REPORT  
FROM  
THE SECRETARY OF WAR,

*A copy of the Survey of the Harbor of Milwaukee; in compliance with a resolution of the Senate.*

TOPOGRAPHICAL BUREAU,  
*Washington, February 25, 1837.*

SURVEY  
of the  
*ENTRANCE to MILWAUKIE*  
WISCONSIN  
1836

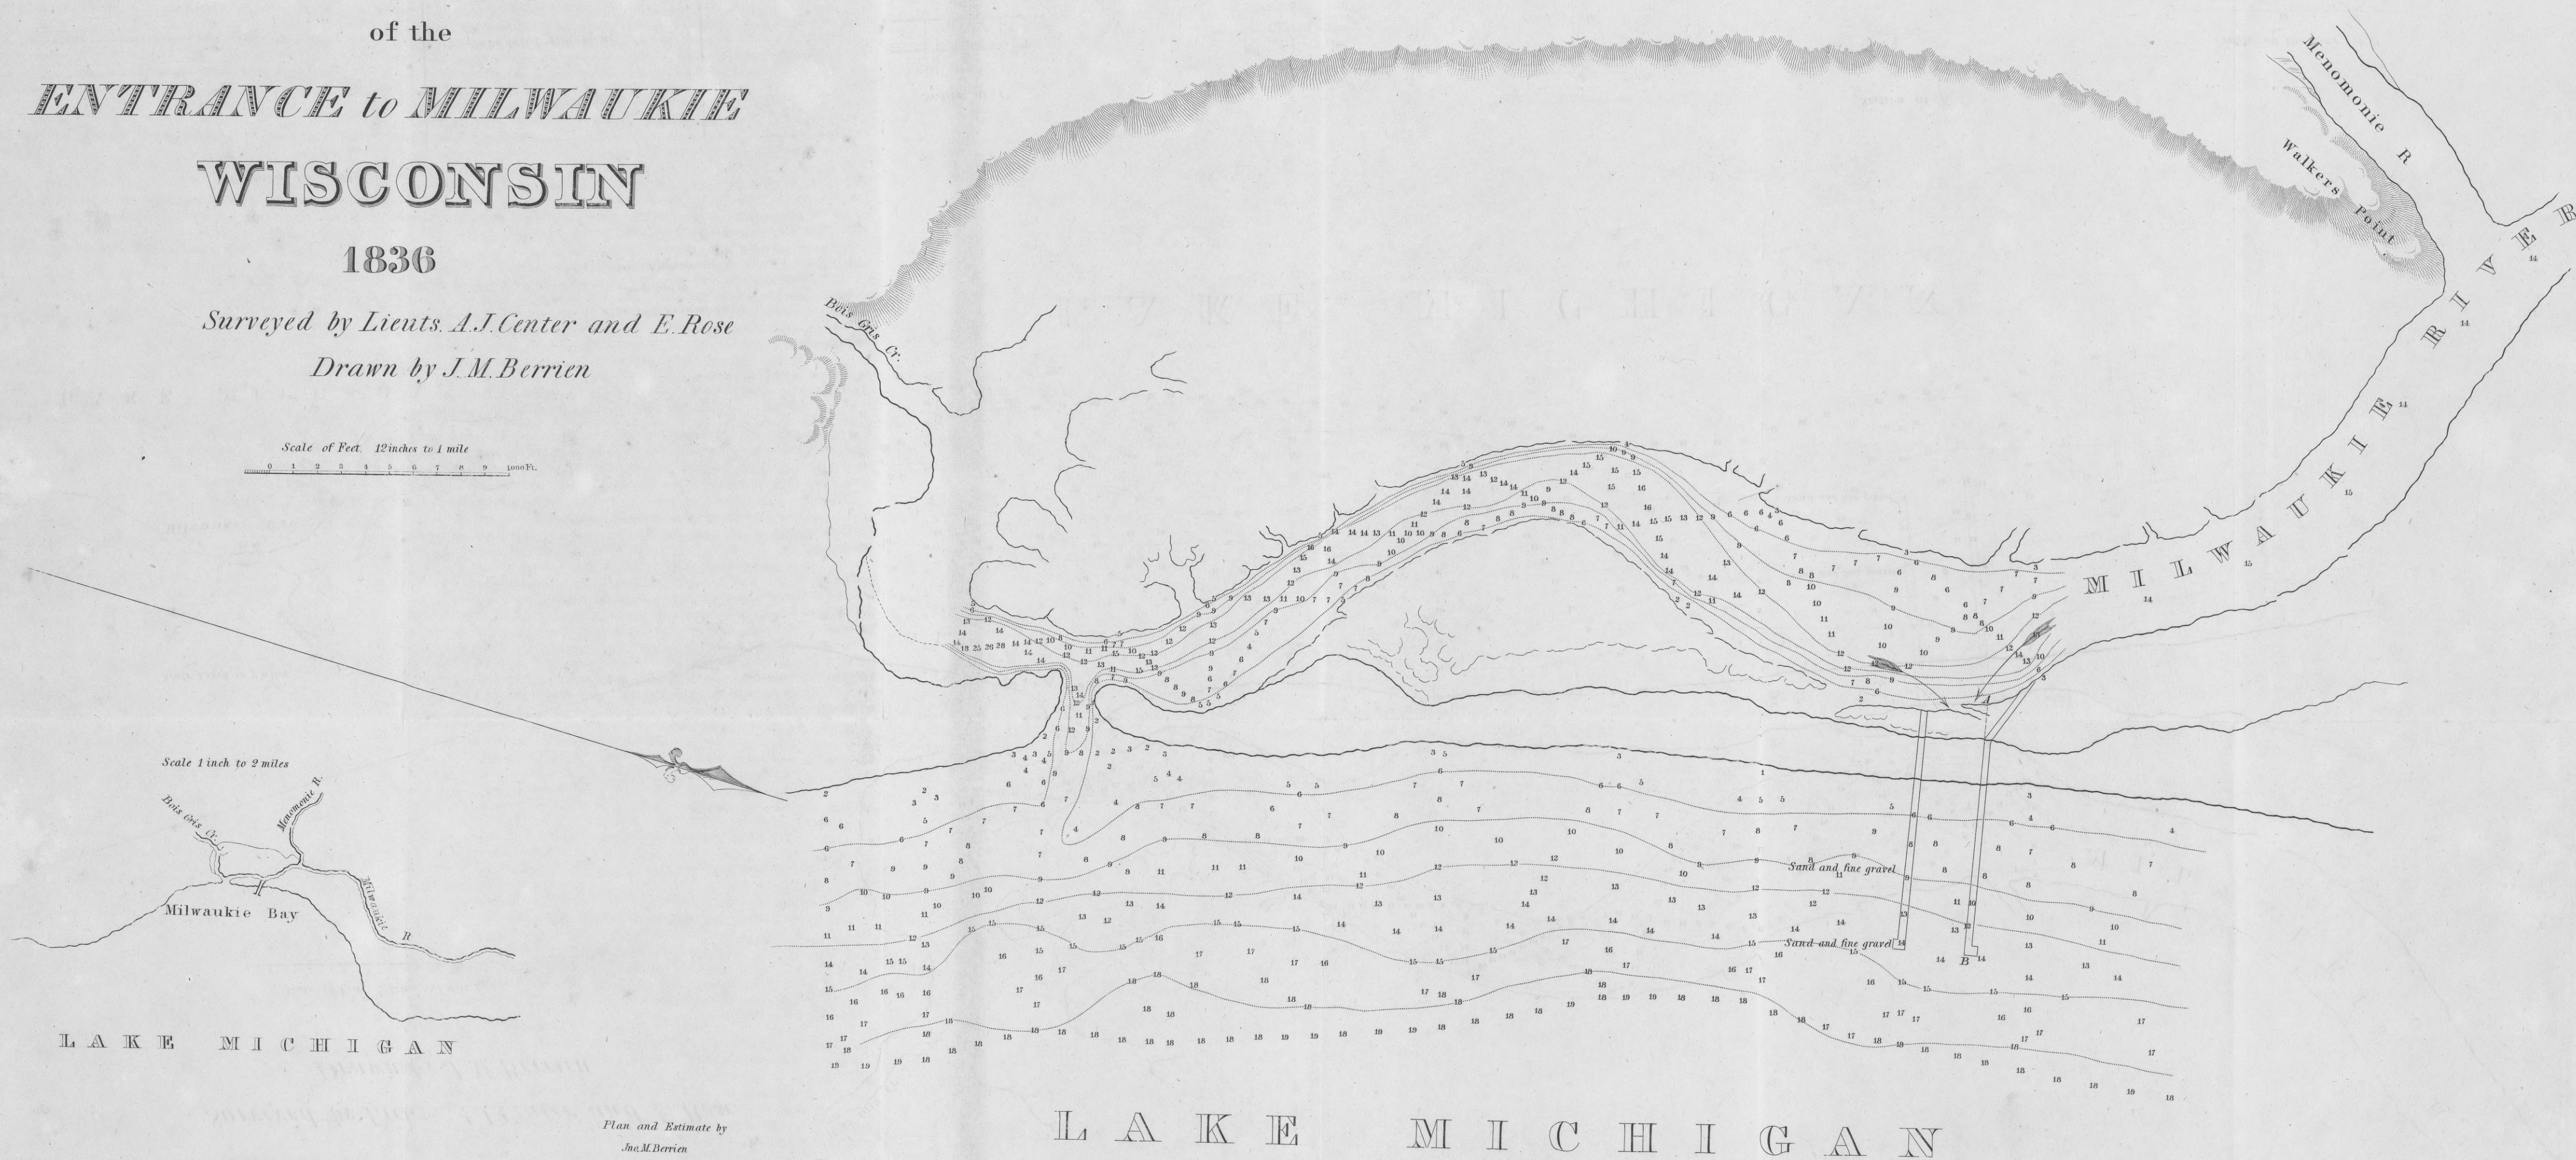
Upon examining the plan and report, objections have occurred to the position of the proposed piers, which are respectfully submitted to your consideration. These are—

1st. That the whole extent of the present fine harbor lying between the position of the contemplated improvement and the natural outlet of the river, would probably fill up, and be in time destroyed, as the only natural means of keeping it open would be from the current of the small stream of Bois Gris creek.

2d. Upon the plan proposed the present outlet would have to be filled up, in order to force the entire discharge of the river through the outlet between the piers, which would increase the cost of the improvement proportionally.

3d. The position proposed for the piers does not appear to possess any advantages over that at the natural outlet, the deep water of the lake being about equidistant from the shore at each place.

4th. The accessory structures for filling up the old outlet and forcing the river to discharge itself through the one proposed, would make the improvement at this latter position much the more costly of the two. And it may further be deserving of consideration, whether the private rights and interests of individuals, acquired under the present position of the outlet and condition of the harbor, would not be so seriously affected by the proposed change of the outlet, as to lay a foundation for claims of remuneration and damages.

From these reflections, while the plan of the structure is approved, the propriety of its proposed position is made doubtful. There may be reasons peculiar to the locality, which may obviate the objections stated; but as these are unknown to the bureau, allow me respectfully to suggest, that any appropriation made for the contemplated improvement may be free from expressions which would fix the position of the piers.
